Re: Stokes Estate Conditional Use  
Westtown Township, Chester County

**RE: Stokes Estate Flexible Residential Development – 927 Shiloh Road, 1007 Shiloh Road, 1011 Shiloh Road, and 1013 Shiloh Road  
Conditional Use Application**

This letter is in response to the June 17, 2023 Cedarville Engineering Group, LLC (CEG) review of the above referenced Plans by D.L. Howell and Associates, Inc.

DATE: 04/14/23  
SCALE: 1"=100'  
DRAWN BY: ADM  
CHECKED BY: DWG  
PROJECT NO.: 3868  
DATE PLOTTED: 06/15/23  
DRAWING NO.: C02.1  
SHEET 07 of 38

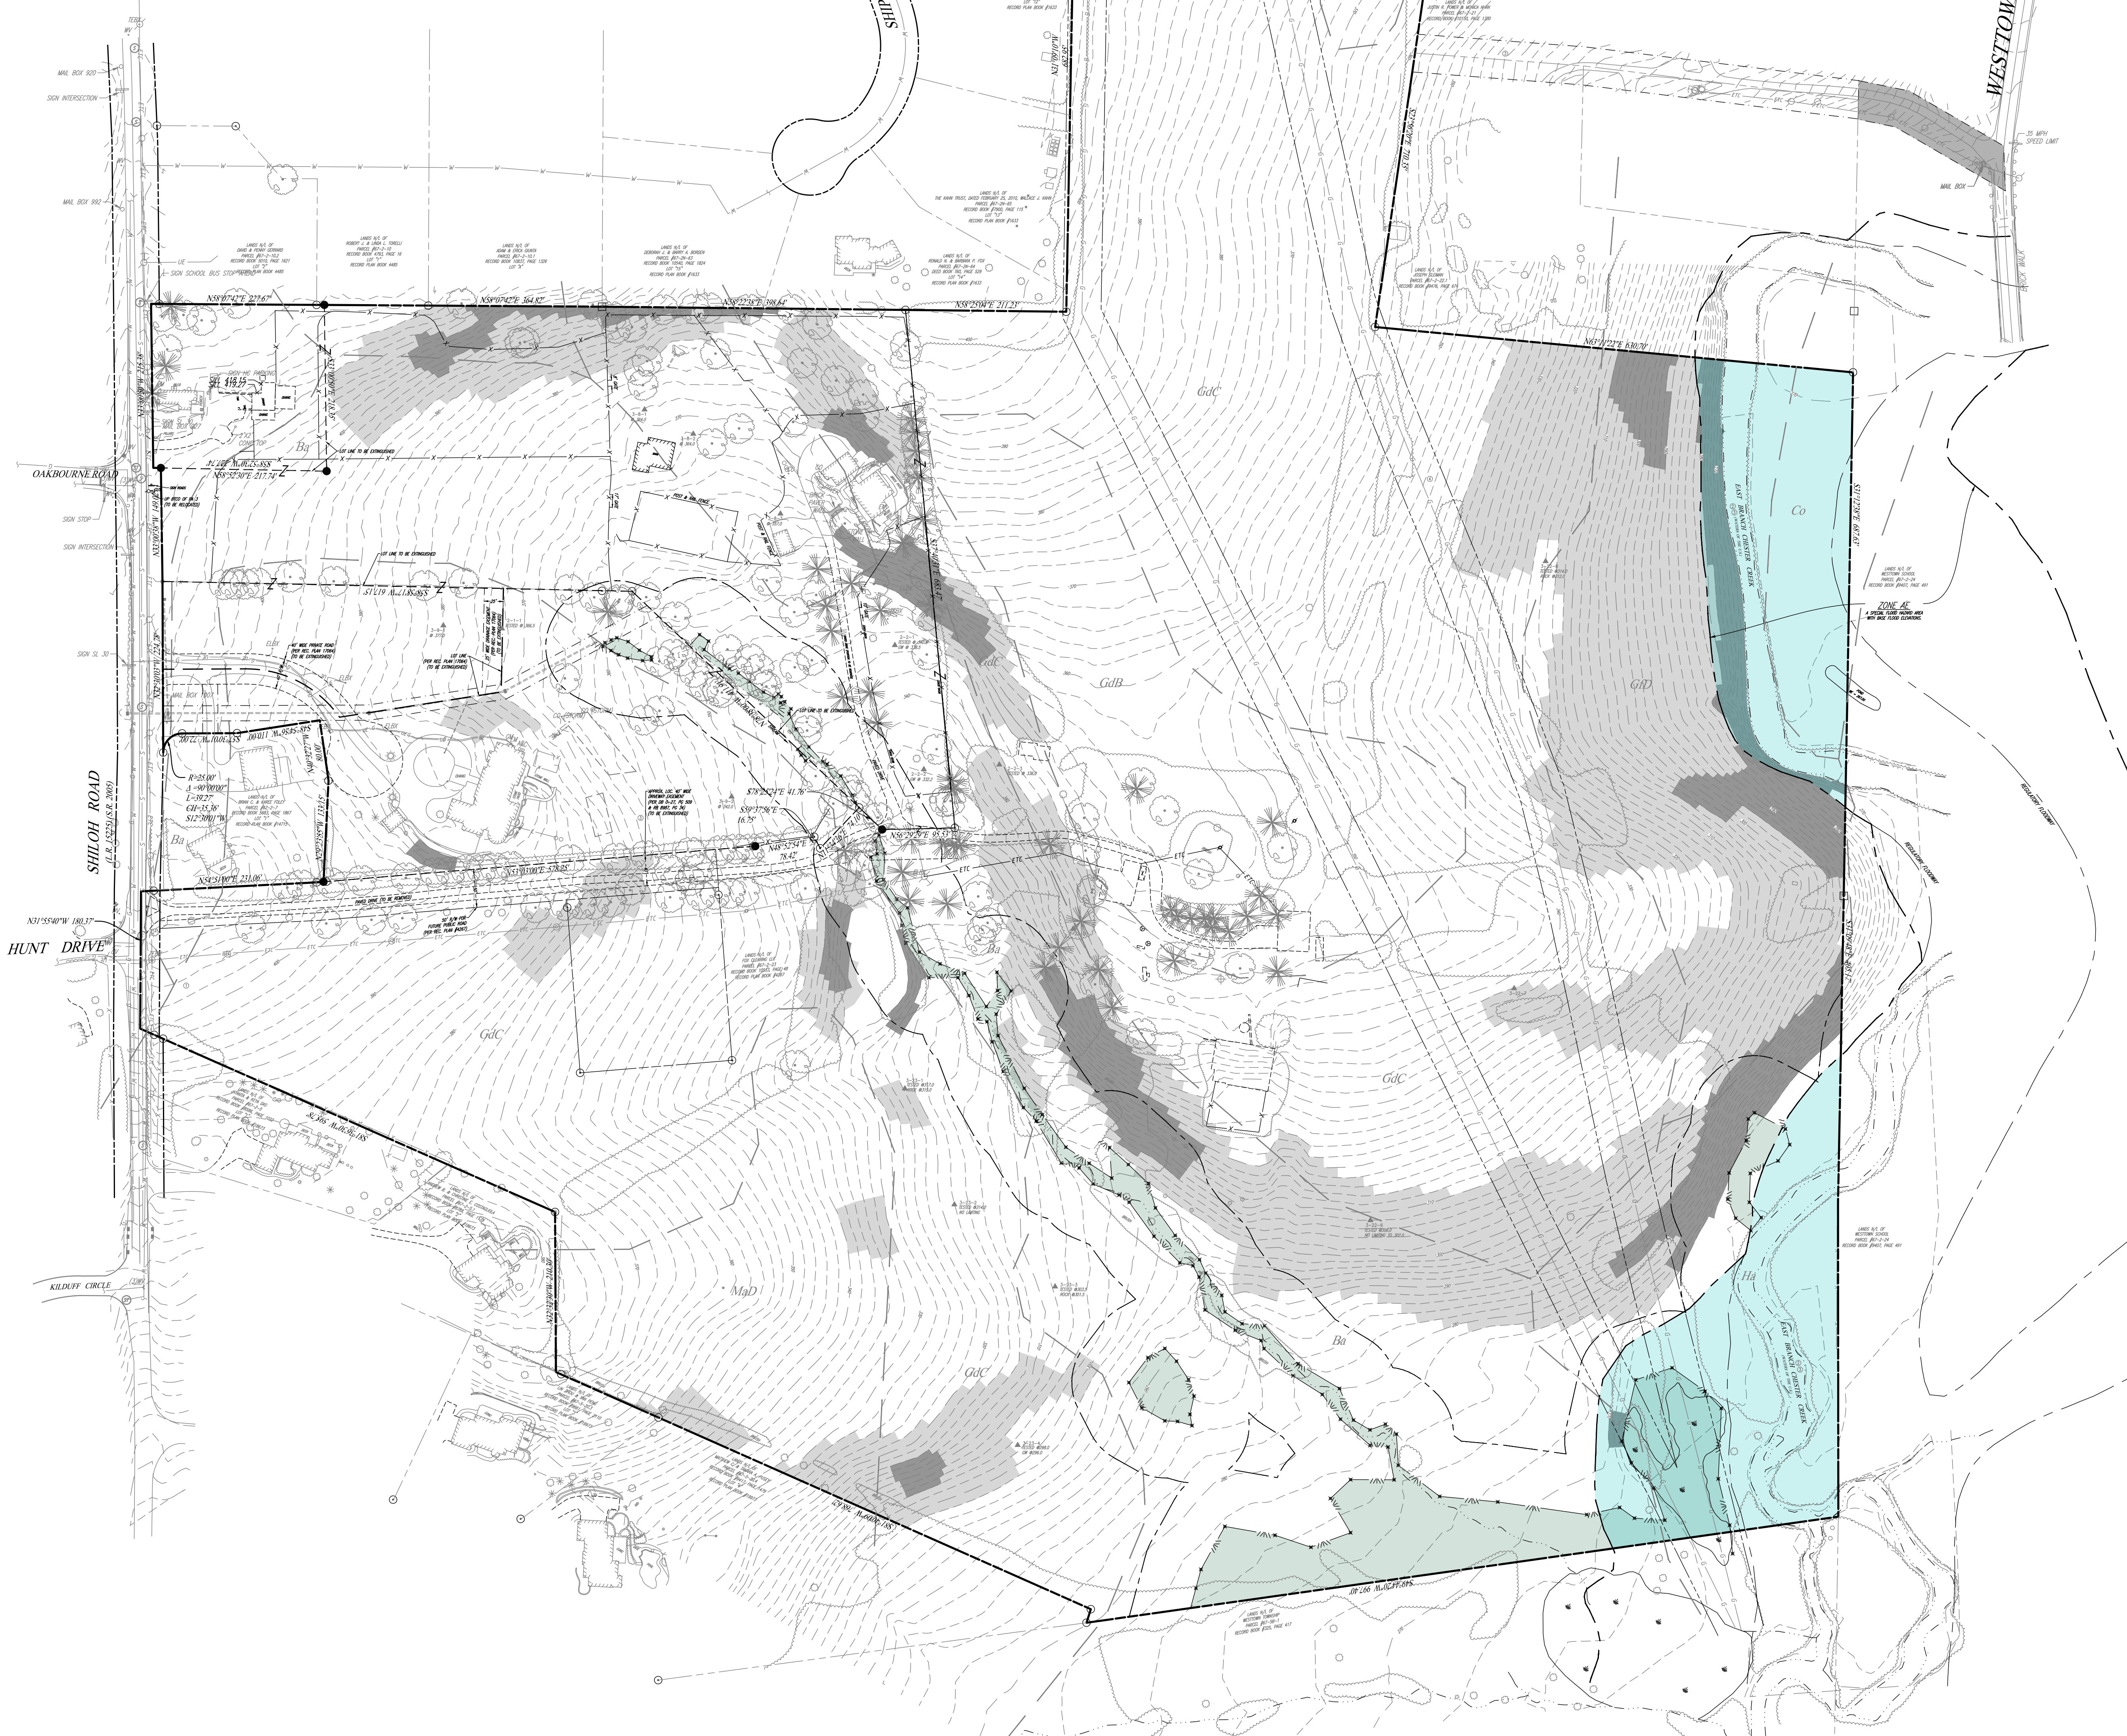
14. The soils legend on sheet 7 shall be revised to indicate which soils have a seasonally high water table.

DATE: 04/14/23  
SCALE: 1"=100'  
DRAWN BY: ADM  
CHECKED BY: DWG  
PROJECT NO.: 3868  
CAD FILE: SITE PLAN.dwg  
PLOTTER: 06/15/23  
DRAWING NO.: C01.6  
SHEET 06 OF 38

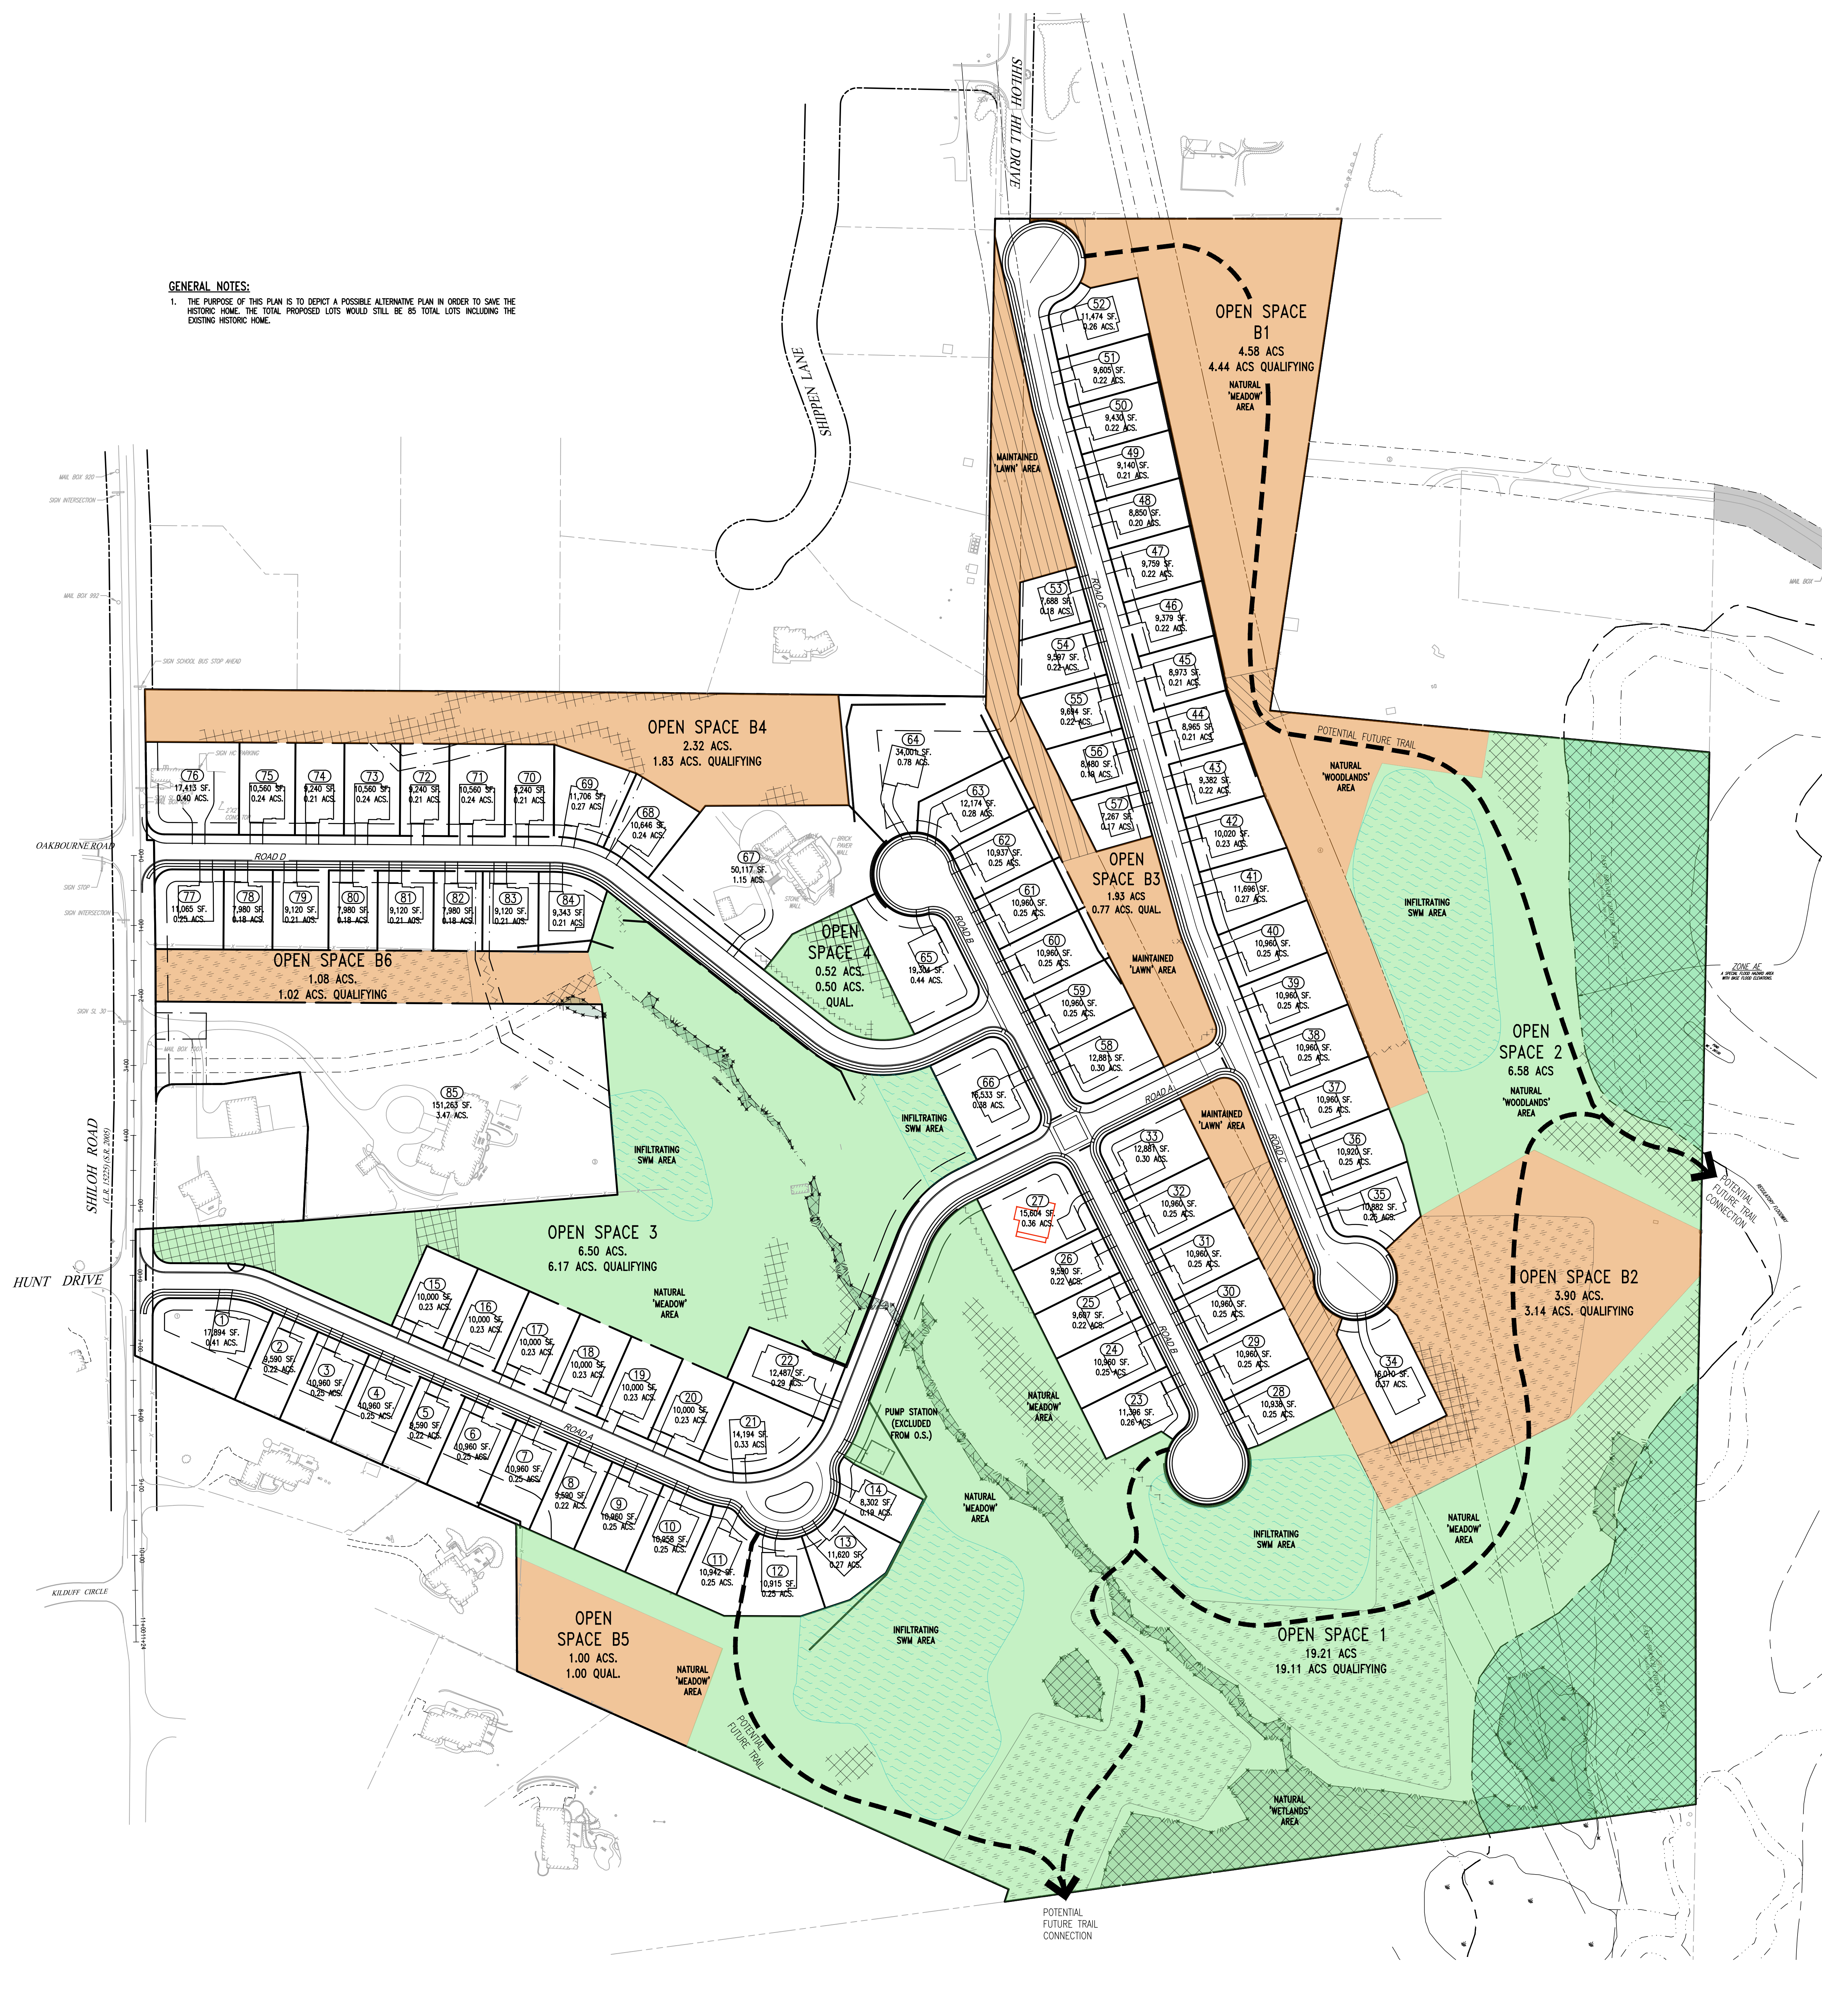
12. Conditional Use Plan set provides a table with calculations (sheet 6) for required minimum common open space and bonus open space with specific exclusions, however, the table does not address proposed impervious surface for trails and potential impervious surface associated with future recreational areas.

22. Conditional Use Plan Set (sheet 6) displays an area totaling 6.61 acres as suitable for active recreation, however, no details are provided on how this area will be used, maintained and/or accessed for recreational purposes. Applicant shall provide additional details on the plan set and/or in a written narrative.

25. Conditional Use Plan set (sheet 36) notes that historic home open space parcel is included as part of the required minimum common open space; however, the parcel includes a house.

**Howell Response: There are currently no proposed impervious surfaces proposed with the active recreation. Due to the location of the trails within and adjacent to natural sensitive areas, ie wetlands, woodlands, slopes, etc., naturalized trails are being proposed.**

**Howell Response: Section 170-907.A.(2) does not require the Applicant to design the active recreational areas. Rather, the Applicant just has to set aside an area that may be suitable. The area set aside is suitable for active recreation.**

**Howell Response: As the Applicant is not seeking any bonus density with the historic preservation, the lot area has been reduced and not included in the open space, therefore this comment is no longer applicable.**
